July 19, 2017

Re: Draft Lake and Streambed Alteration Agreement, Notification No. 1600-2017-0135-R1, Marble Mountain Ranch Diversion, Stanshaw Creek

EXHIBIT A

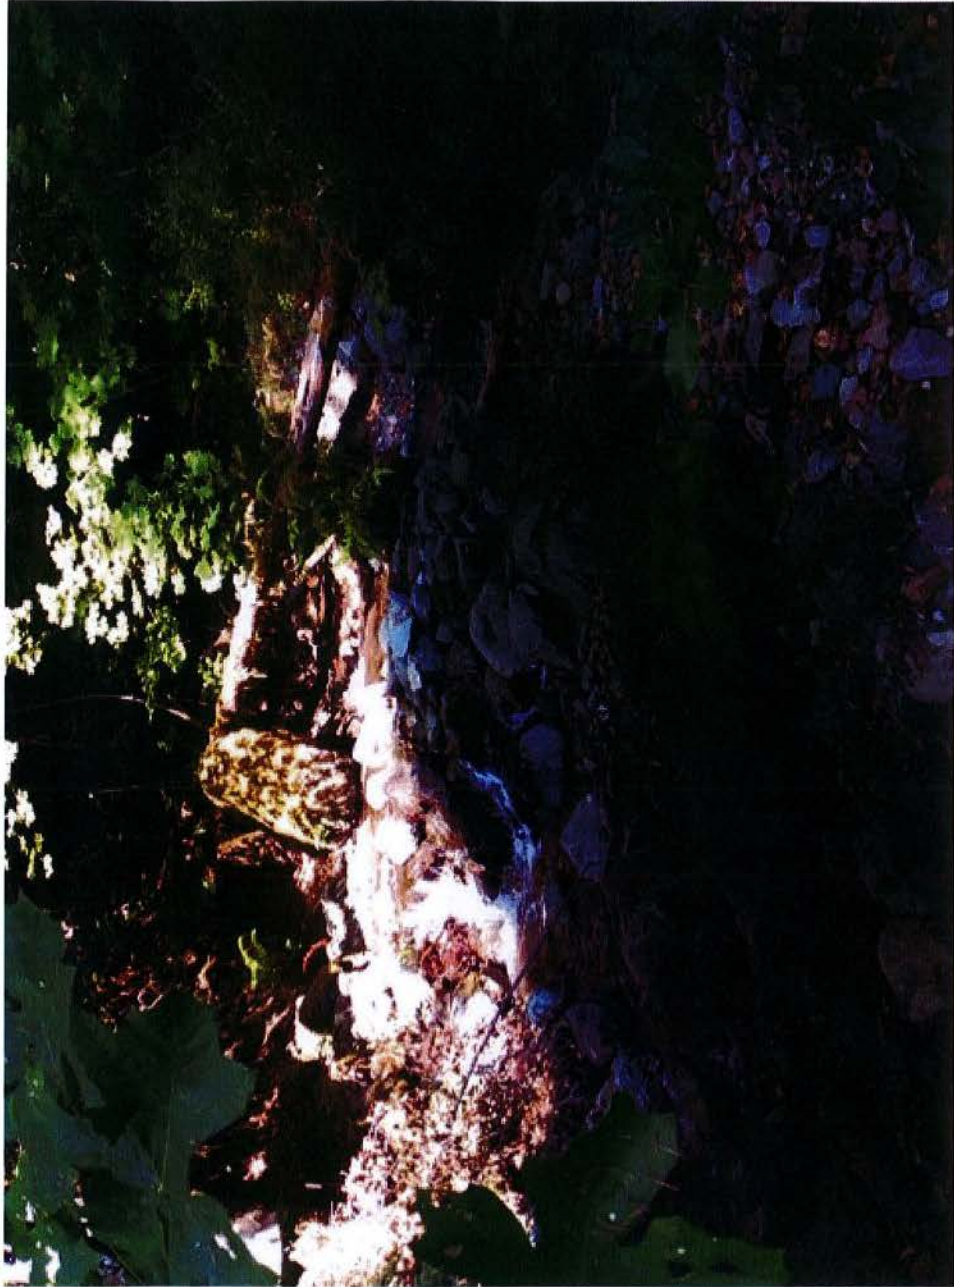
The Agreement proposes to limit the length of the wing dam used to divert water into the Coles' diversion to 25% of the active channel of Stanshaw Creek. The geomorphology of Stanshaw Creek requires a longer wing dam to properly divert water into the Coles' diversion. The photograph of the point of diversion, attached hereto as **Exhibit A**, demonstrates the typical flow and structure of Stanshaw Creek at the point of diversion during the late summer and early fall. The photograph makes clear that the wing dam must enter more than 25% of the active channel in order to divert water for consumptive and domestic use at the Ranch. Therefore, this term of the Agreement must be amended to reflect Stanshaw Creek's geology and allow the Coles to extend the wing dam beyond 25% of the active channel.
